City of Biddeford
Planning Board
December 20, 2023 6:00 PM City Hall
Council Chambers, & Zoom
<https://biddeford.zoom.us/j/94983531202?pwd=Q3ZyejcyUVpBaUVVMHduYXJhSzB4UT09>
Webinar ID 949 8353 1202; Passcode 223739

Case 2023.44: Preliminary Site Plan Review for Everybody Loves Raymond St, LP / Proposed Construction of a 10-unit residential structure on Raymond Street (Tax Map 29, Lot 108).
Planning Board Hearing date: December 20, 2023.

Per your request Site Design Associates has undertaken a review of the plans and documentation submitted in support of a site plan application for the referenced project. Our review was based on preliminary civil engineering plans dated 11-22-23.

NOT TO SCALE

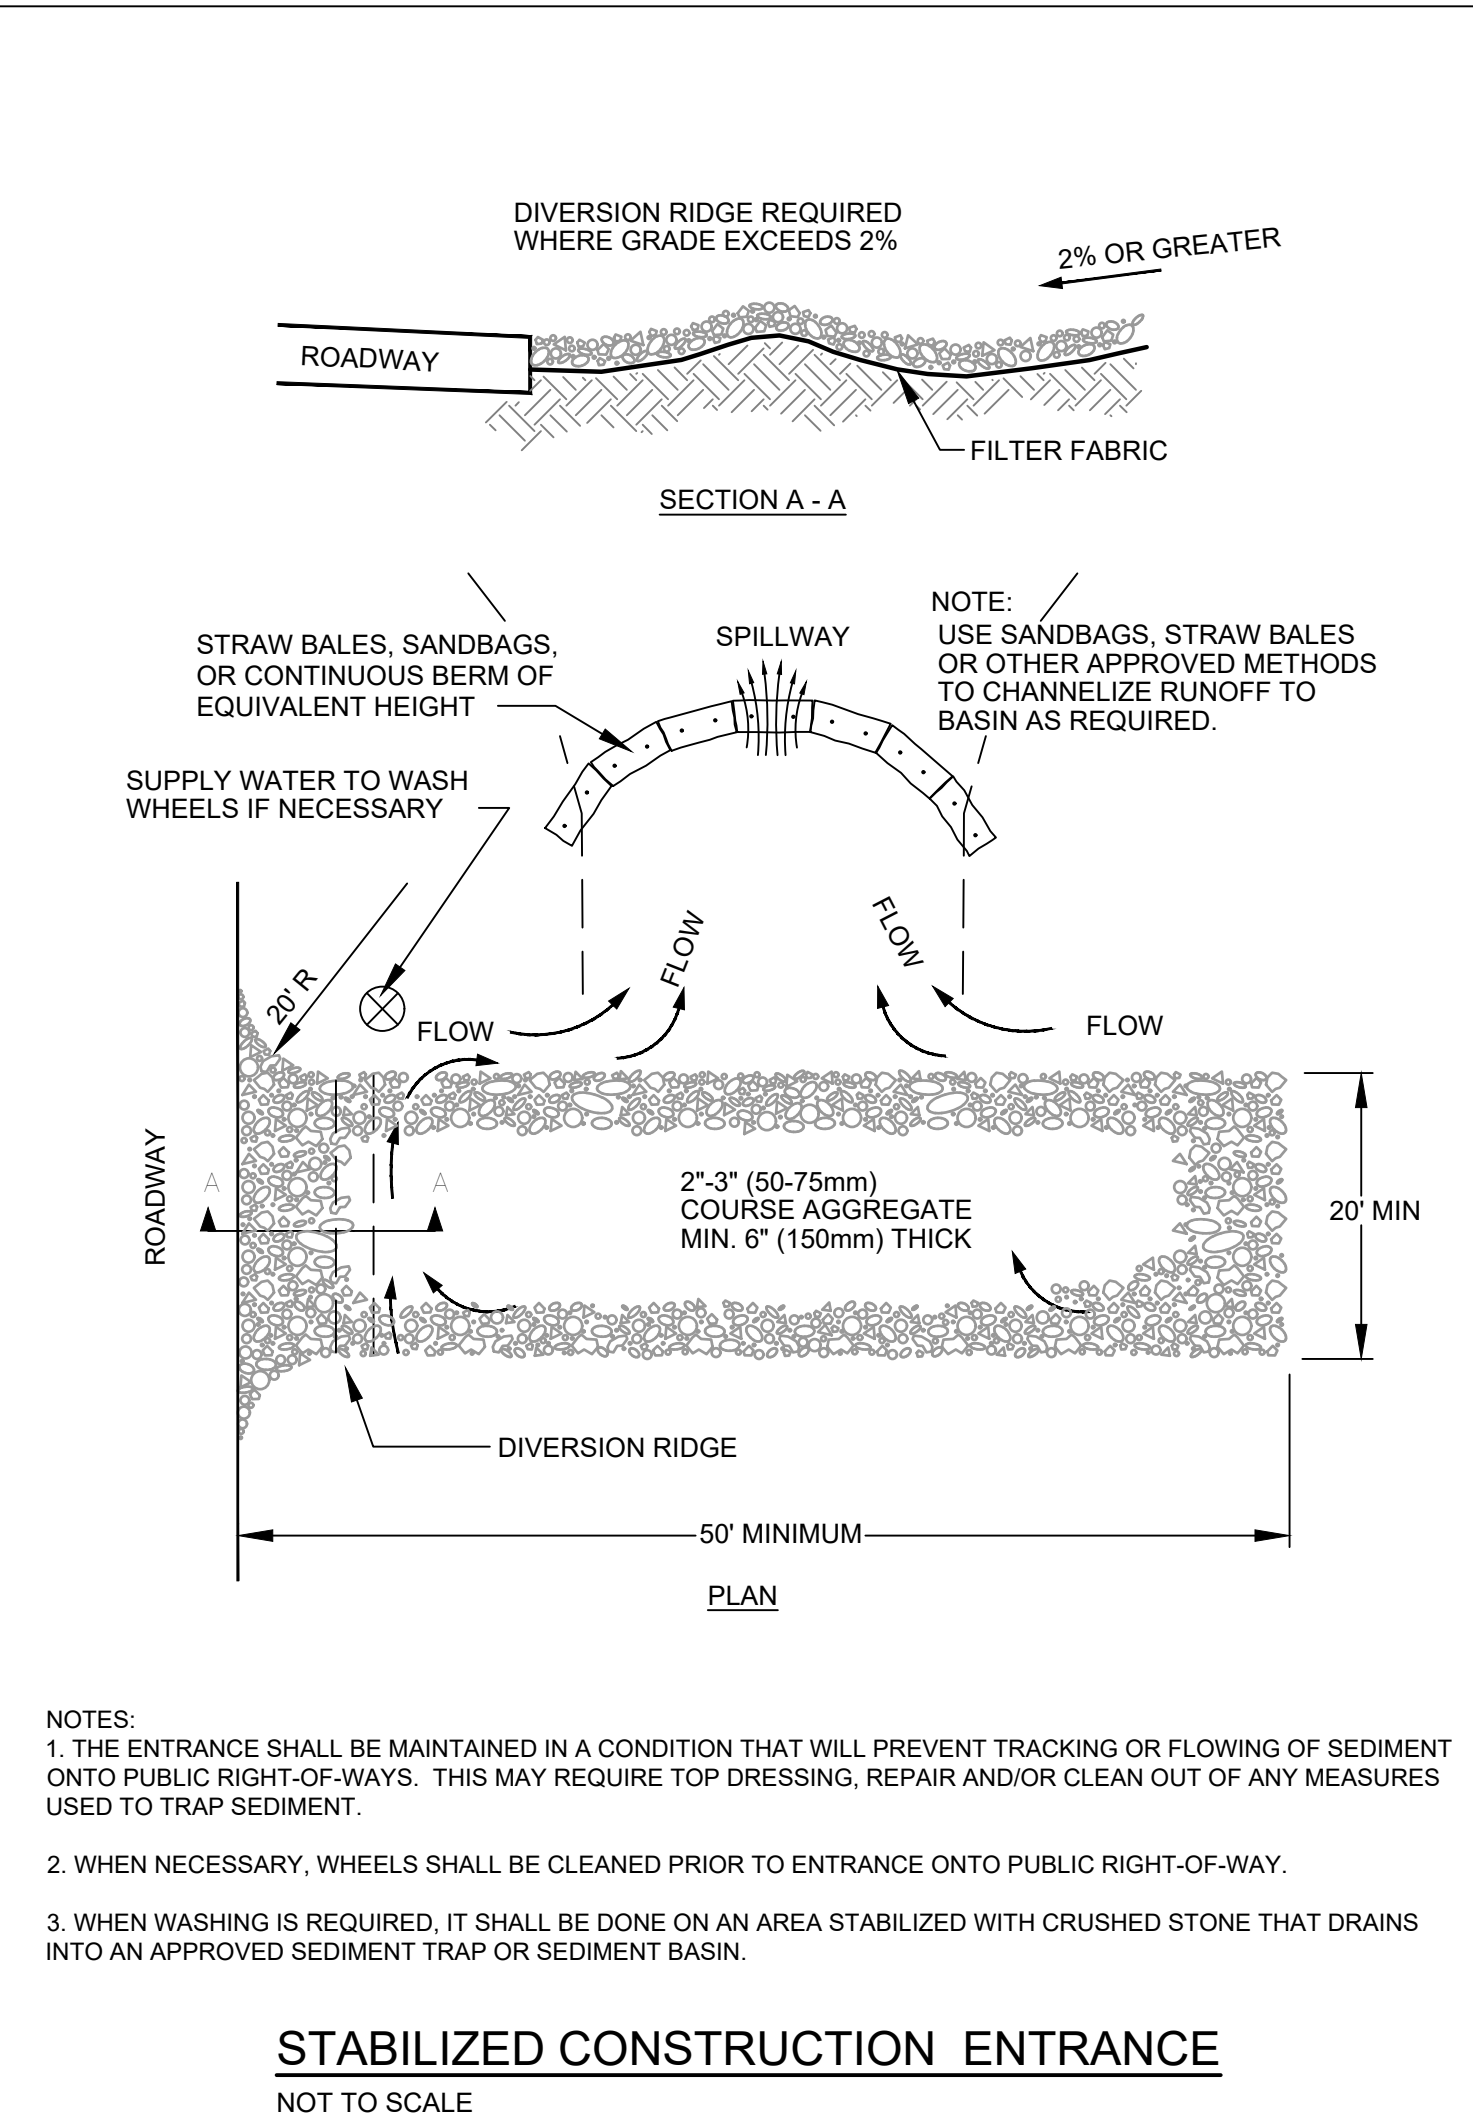
- a. Requirements for inspections during construction outlined in Chapter 500, Appendix B.1. should be included on Drawing C-6.0 and should be consistent with the requirements of the MDEP stormwater checklist.

- b. It is not clear the 7 ft x 12 ft x 1 ft deep sediment basin will be effective in providing sediment migration from the site. How was this sized?
- c. Rather than calling for the saw cut and removal of surface pavement on the pavement joint detail, the outside 1 ft should be milled to the depth of the surface course. The sawcut through the entire existing pavement section would occur 1 ft from the milled section.

OUTLET CONTROL STRUCTURE (OCS)
NOT TO SCALE

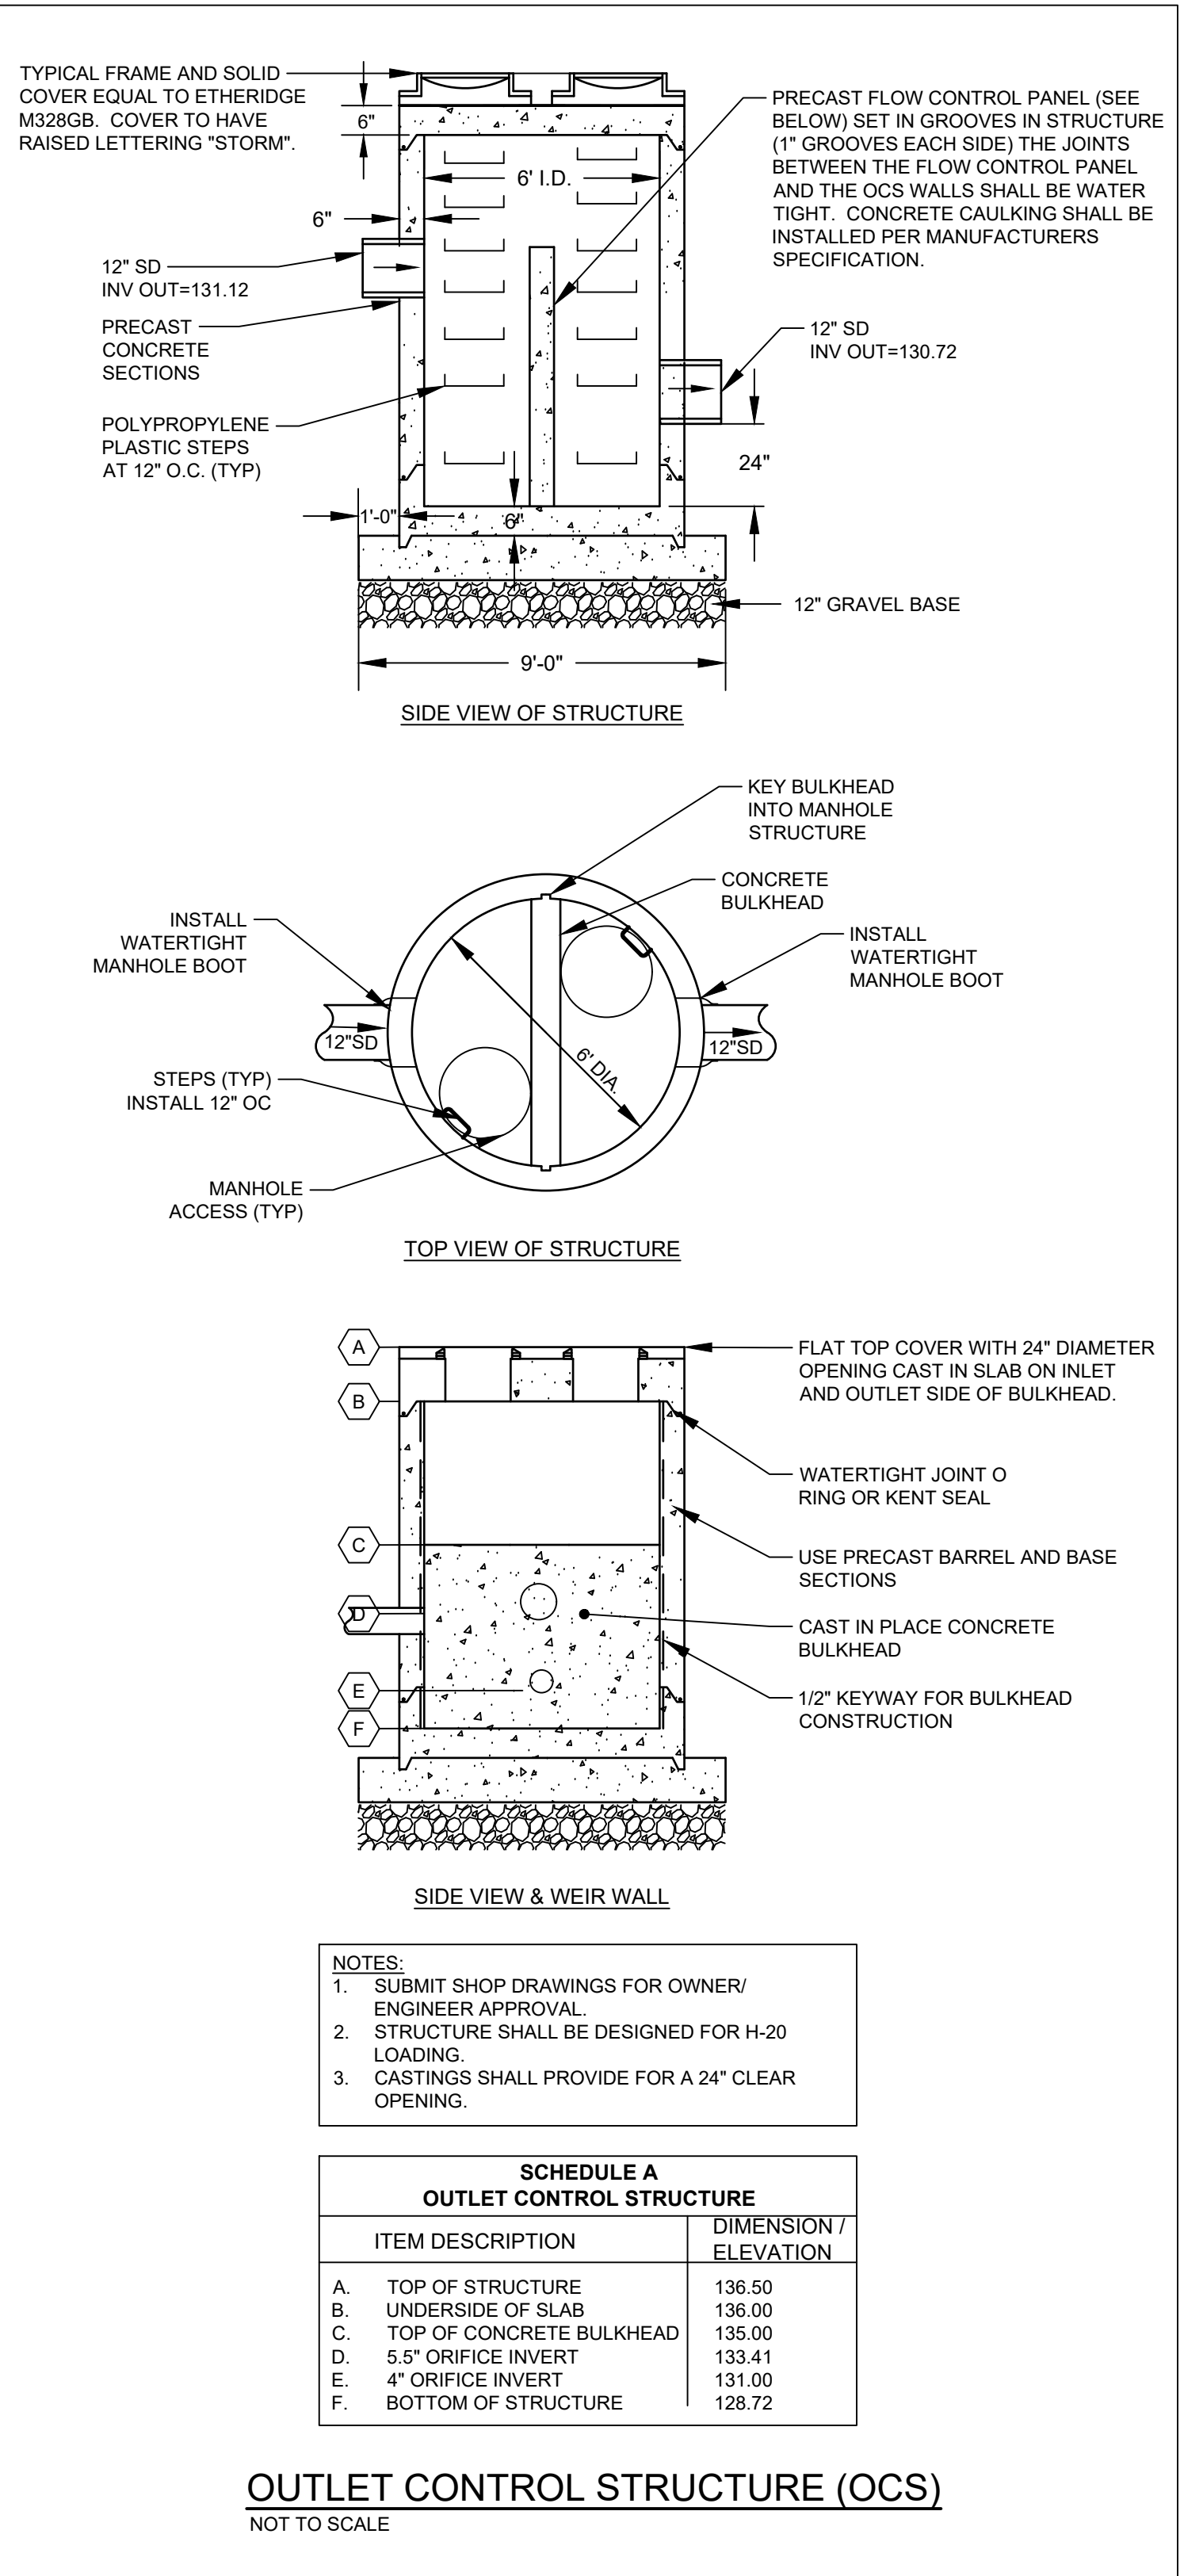
- f. Some elevations and orifice sizes conflict with the stormwater model.
- g. The OCS detail appears to show a slab under the barrel section. Is that the intent?
